REGULATION NO. 14  
(Safety-belt anchorage)

**REMARKS CONCERNING THE PROPOSAL FOR THE MODIFICATION  
OF THE DEFINITION OF EFFECTIVE ANCHORAGE.**

Transmitted by the Experts from Romania

Figure no. 1

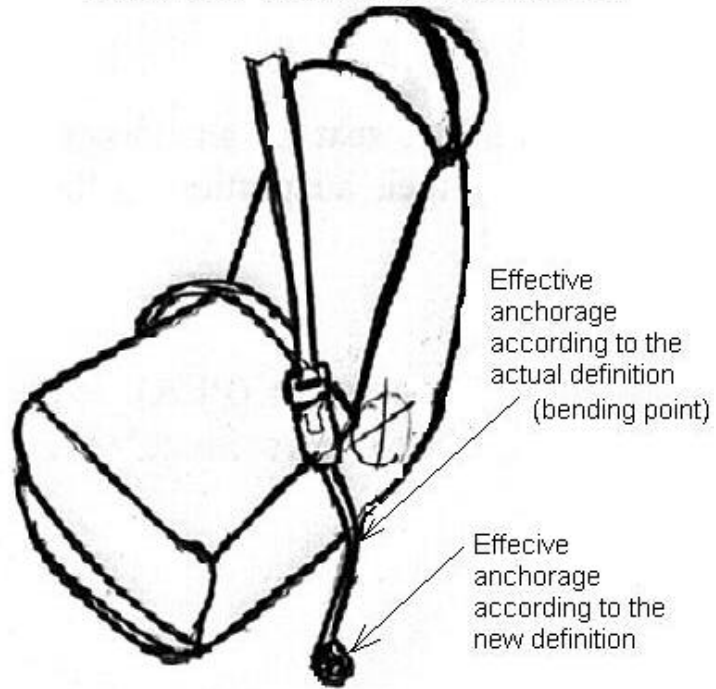
1. We consider that the proposed new definition don't allow to correctly define the effective anchorage in some cases.  
For example, we present the case of an inferior anchorage with flexible cable for front seat (figure no. 1).

Using the actual definition, the manufacturer and the Technical Service defined the effective anchorage being the bending point of the cable (figure no. 1 and 3).

We consider that this position is correct because the real geometry is reproduced.

If it is used the new proposed definition, the effective anchorage should be placed on the inferior fixing point of the safety belt on the vehicle (that is the last rigid part contacted by the safety belt, figure no. 1).

We consider that this position is not appropriate because the geometry is not the same like in the real case.

Figure no. 2

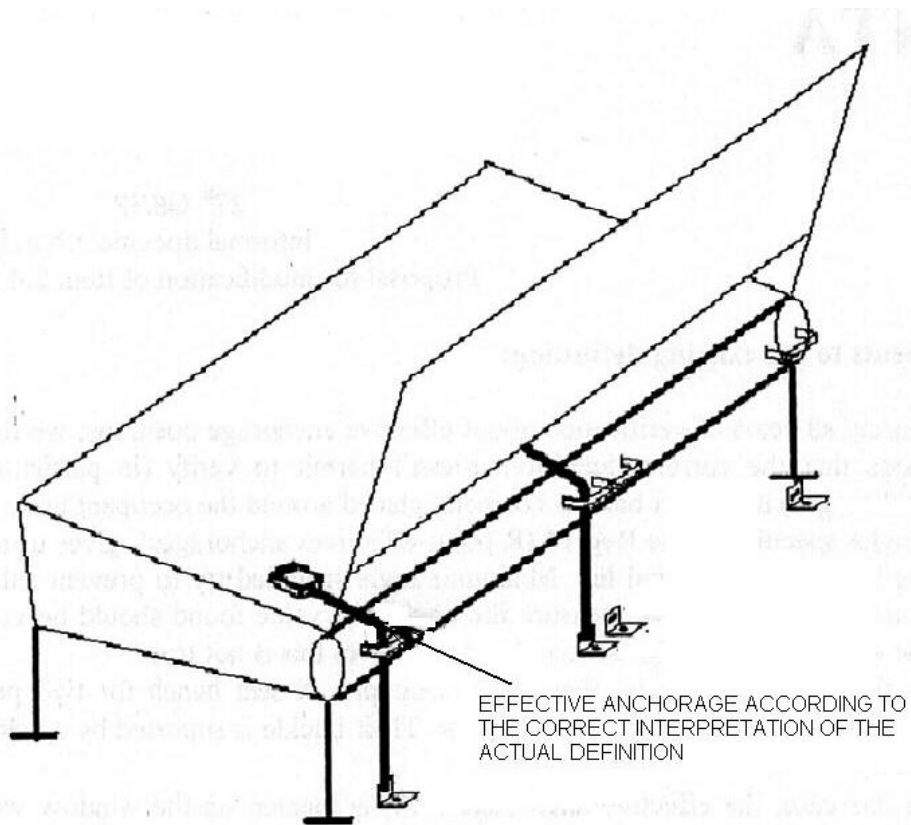
2. Regarding the example described in the document TRANS/WP.29/GRSP/2000/10, our opinion is that according to the actual definition of the regulation, the effective anchorage point is the bending point of the supporting belt or flexible cable (figure no. 2).
